#### ADDENDUM #2

## Will County Health Department BID PACKAGE #3 – MEP/Finishes/Carpentry/Glazing December 4, 2018

#### SECTION 00 91 08 BP #3 - ADDENDUM NUMBER 2

PROJECT: WILL COUNTY HEALTH DEPARTMENT - NEW HEALTH DEPARTMENT

SECOND FLOOR STRUCTURED CABLING - AREA 'A'
SCALE: 1/8" = 1'-0"

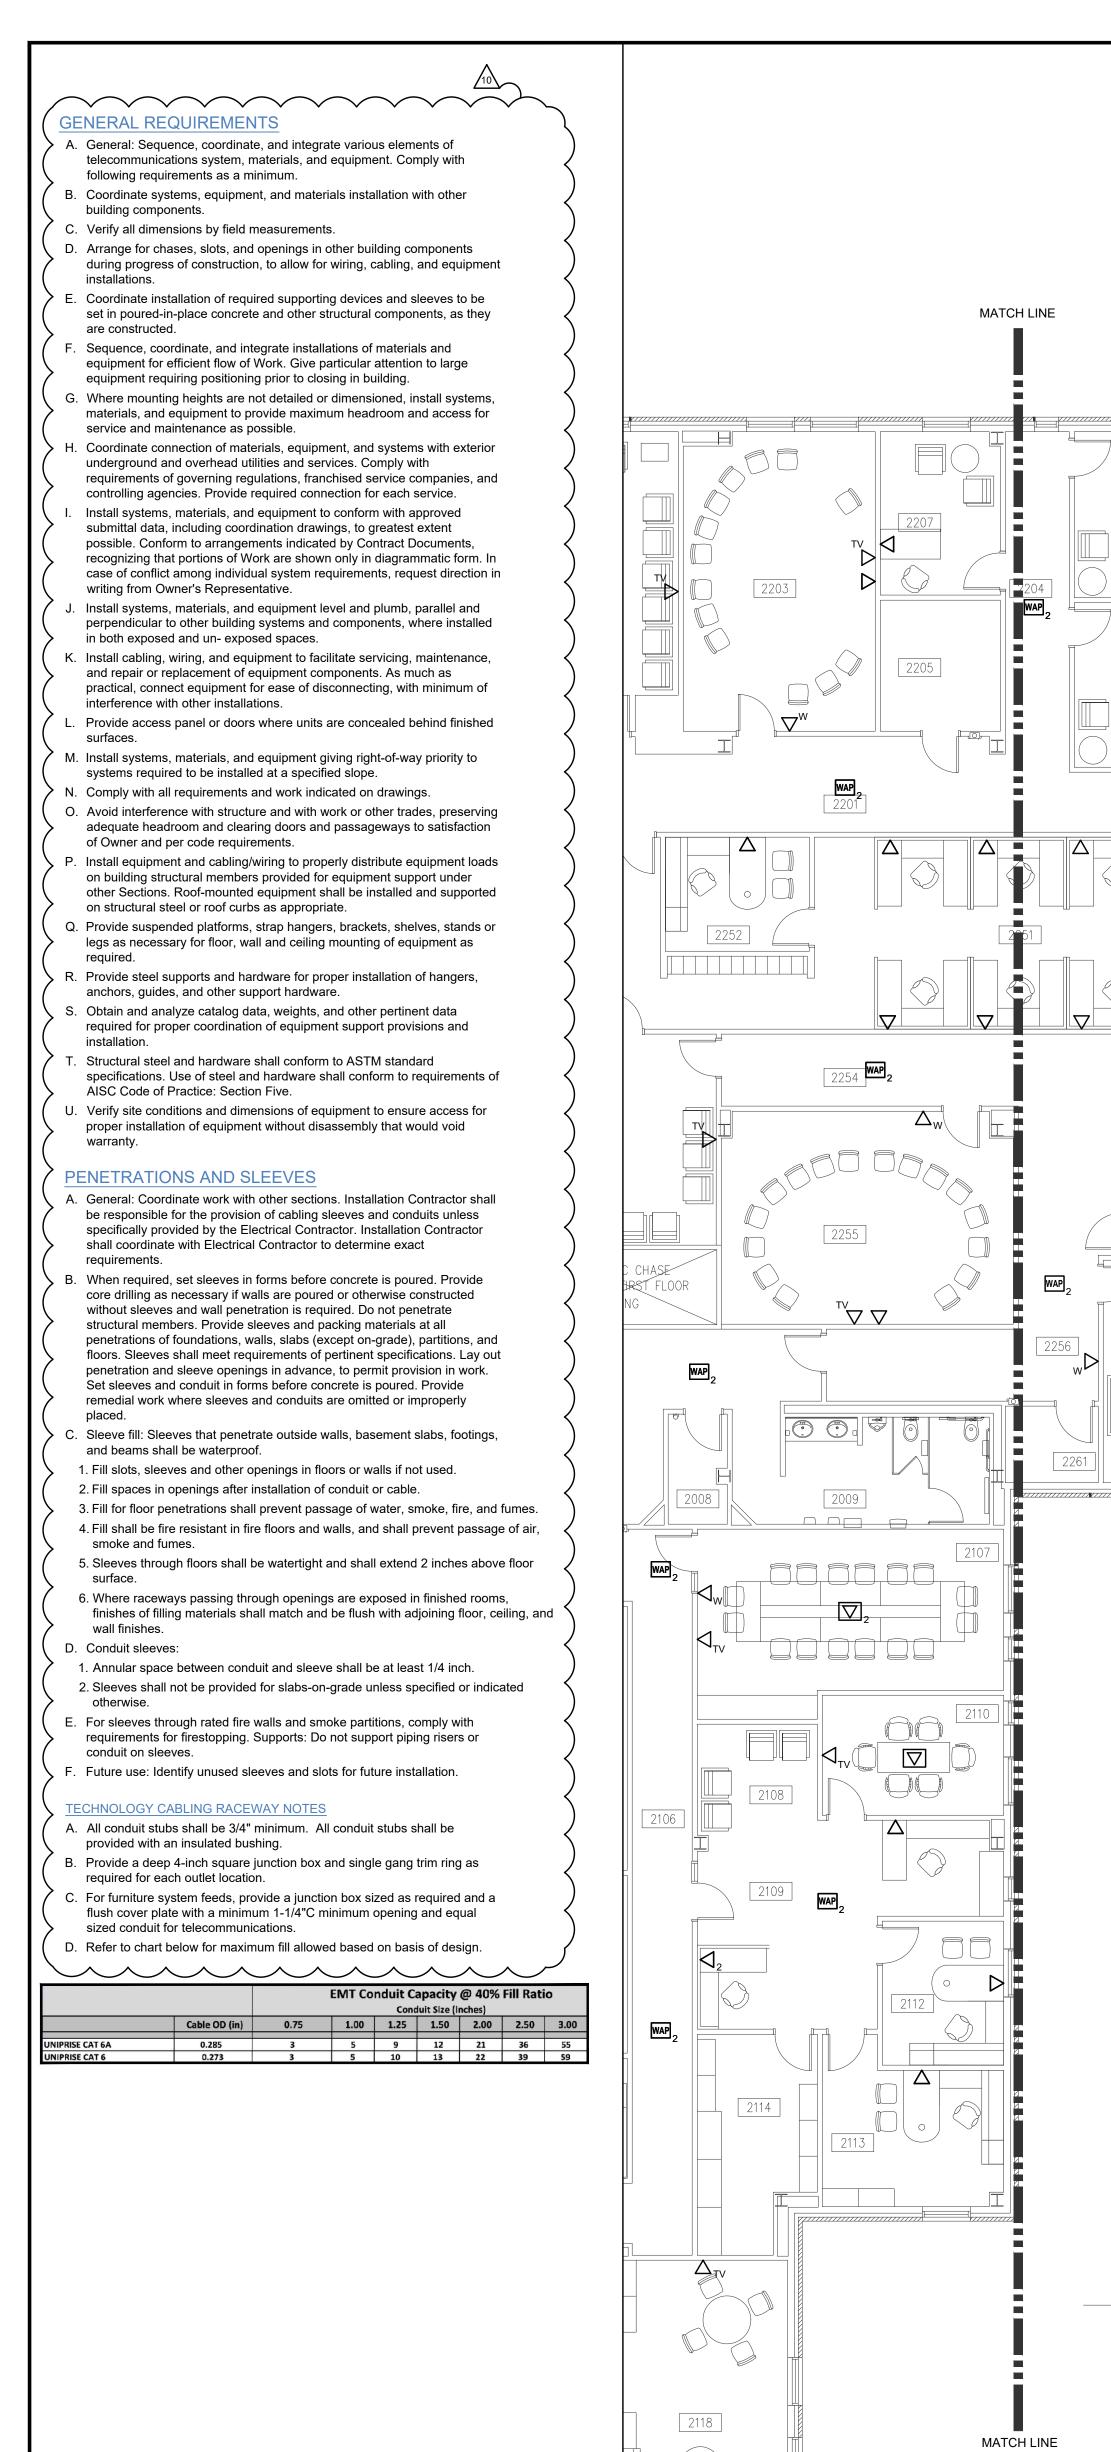
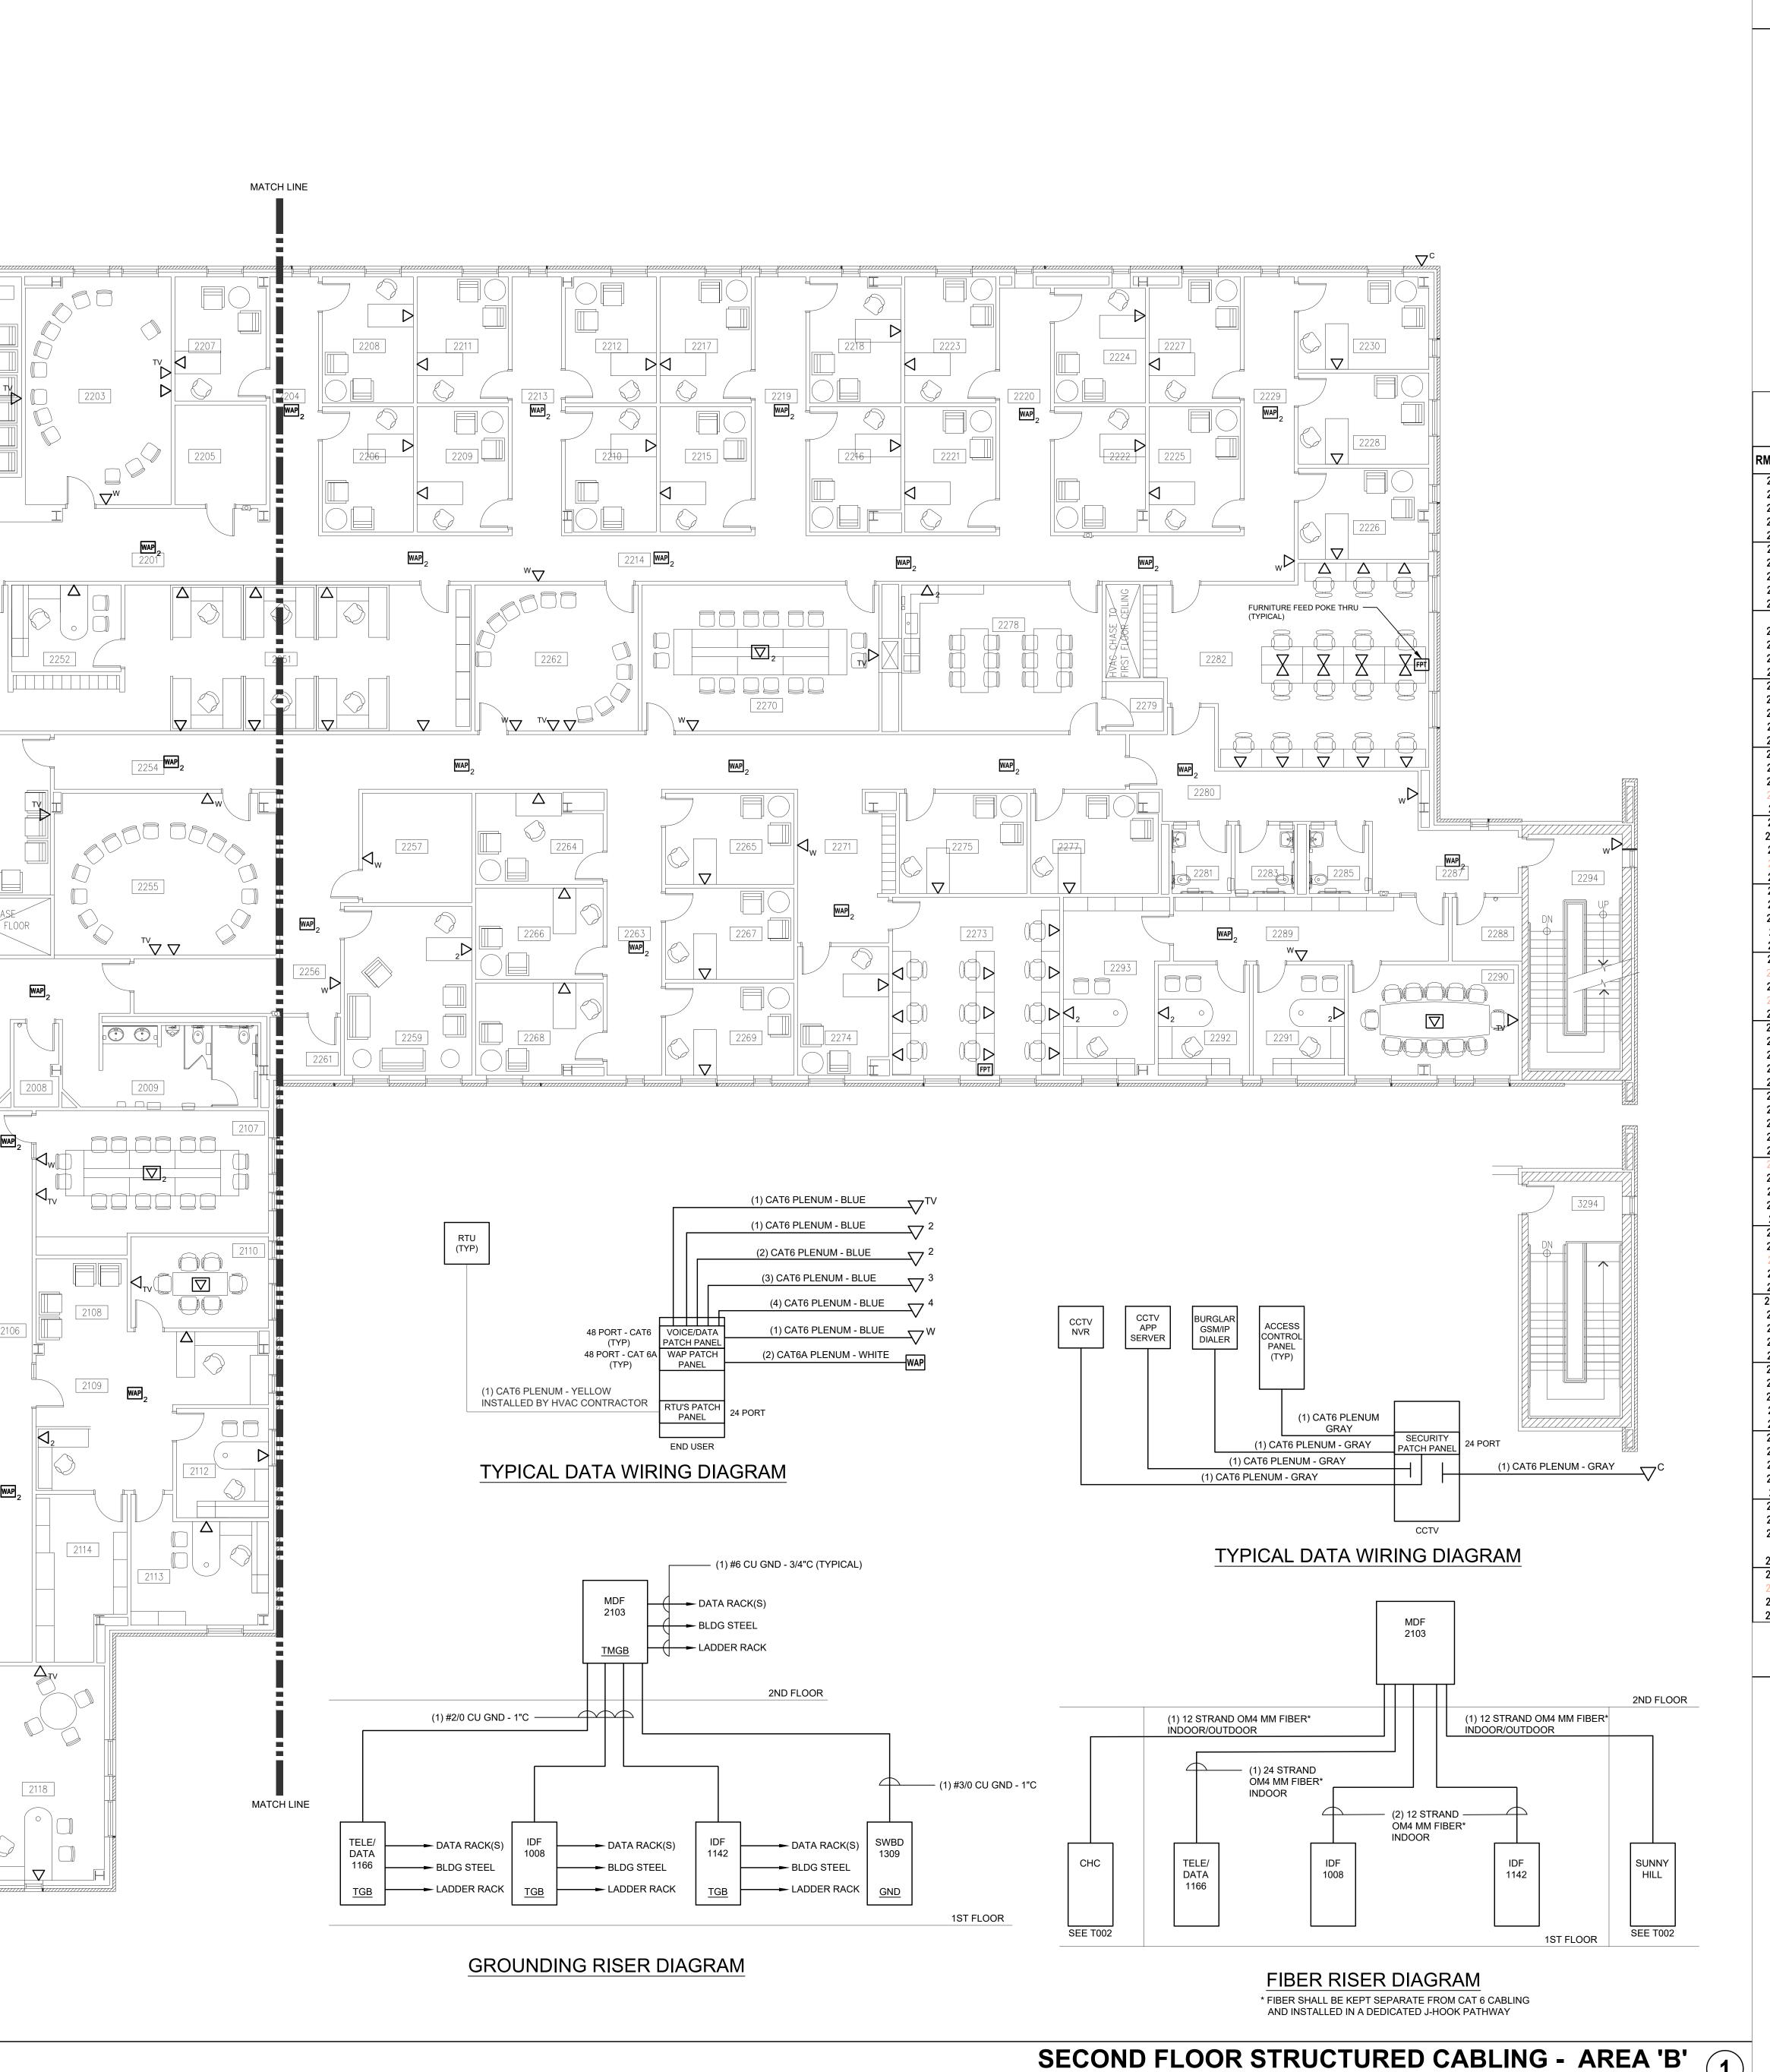
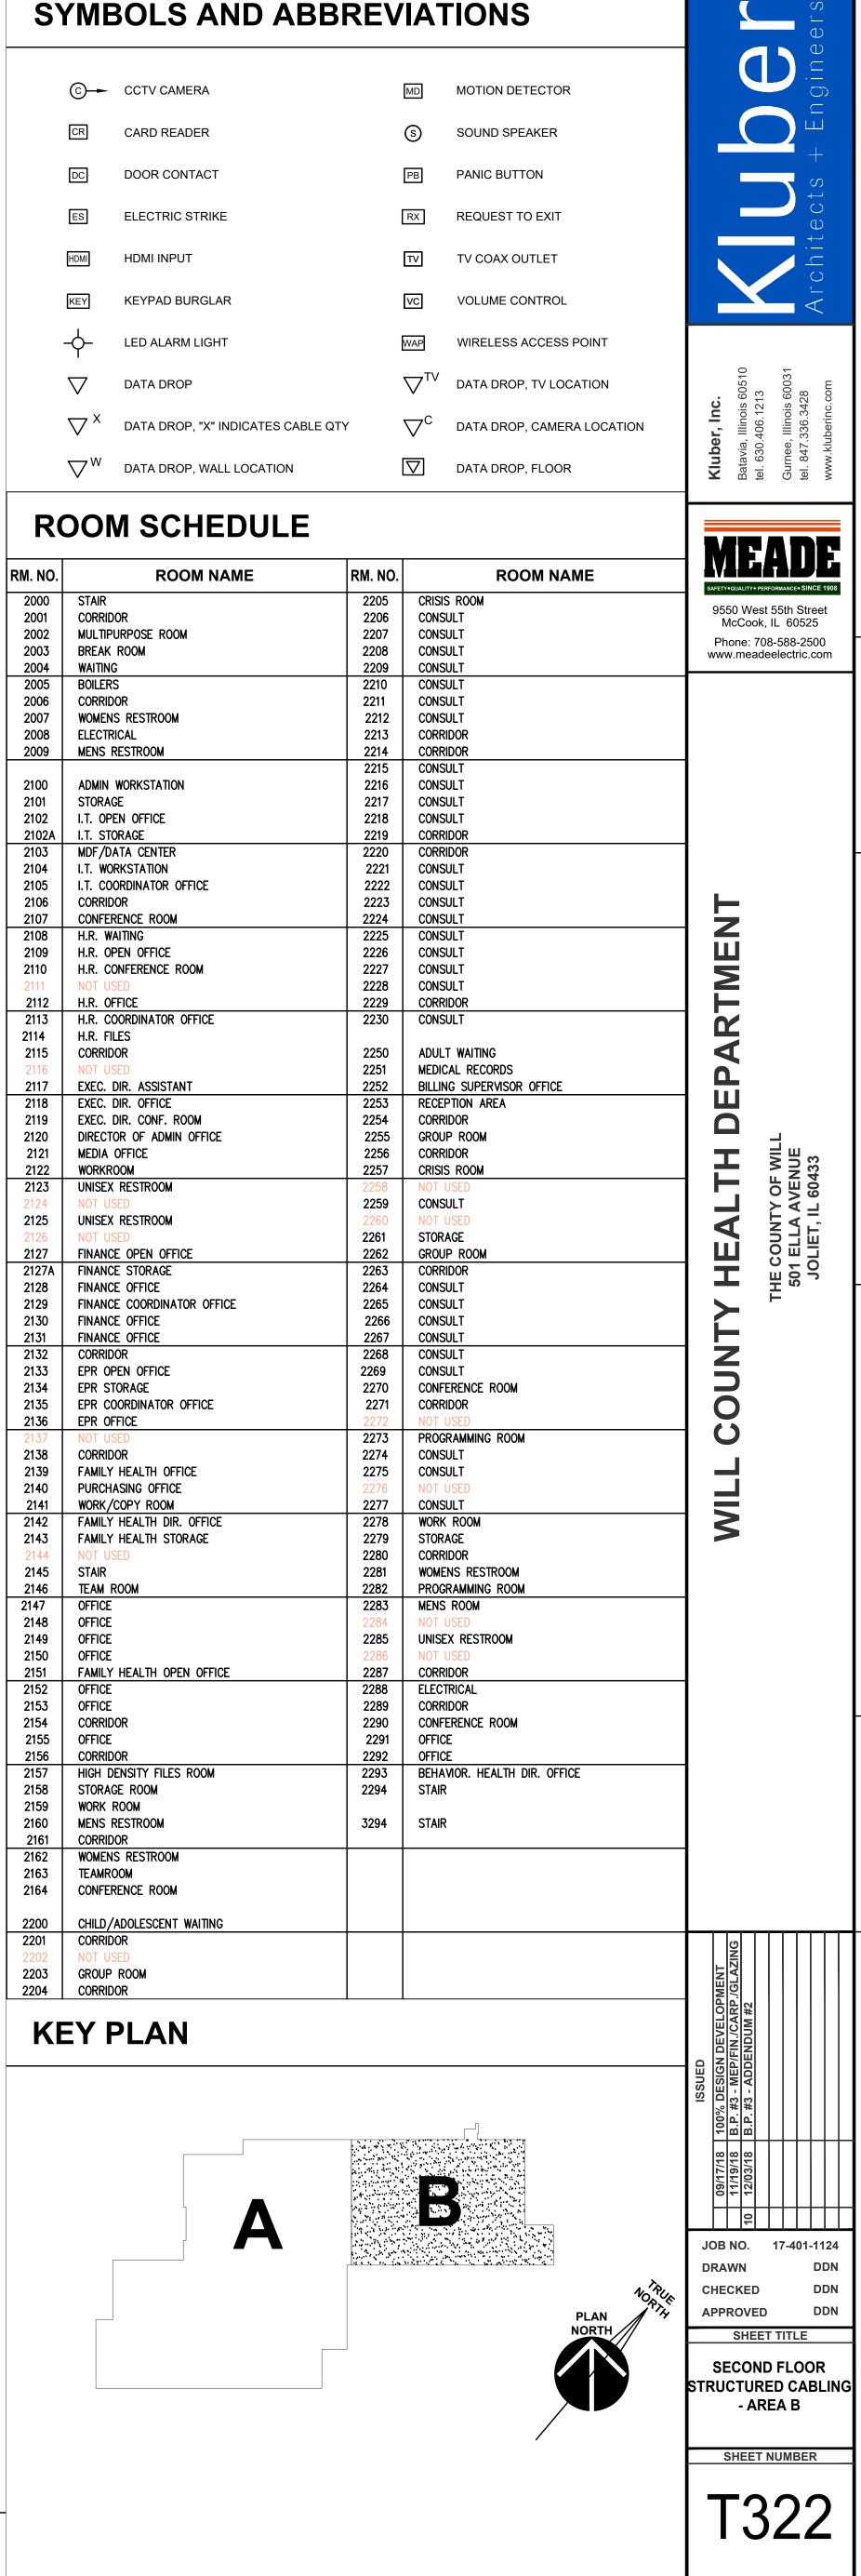
A. Corrected text font error, provided fiber and Tele/Data equipment clarification.
